SUBJECT: PALISADES NUCLEAR PLANT – SUMMARY OF CONFERENCE CALL
REGARDING THE SPRING 2012 STEAM GENERATOR INSPECTIONS
(TAC NO. ME8129)

PALISADES NUCLEAR PLANT SPRING 2012 (1R22) OUTAGE STEAM GENERATOR

STEAM GENERATOR TUBE INSPECTION DISCUSSION DURING PALISADES 2012 (1R22) OUTAGE

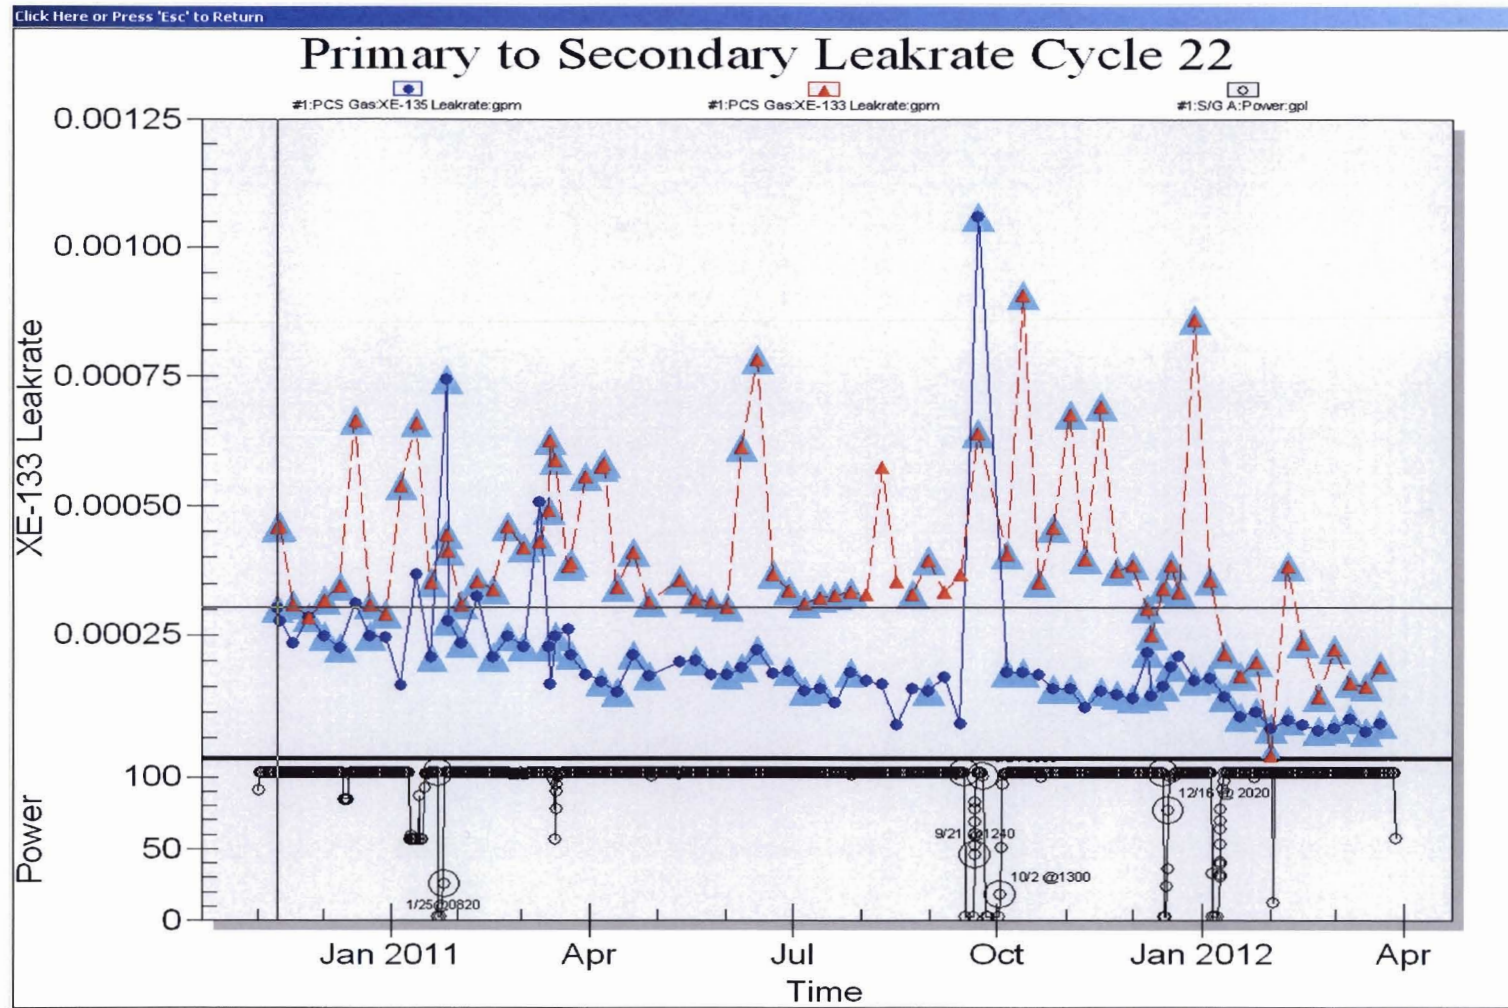
1. Discuss any trends in the amount of primary-to-secondary leakage observed during the recently completed cycle.

Refer to attached Primary to Secondary Leak Rate for Operational Cycle 22 Primary to Secondary Leak Rate graph. Leakage has been minimal all cycle
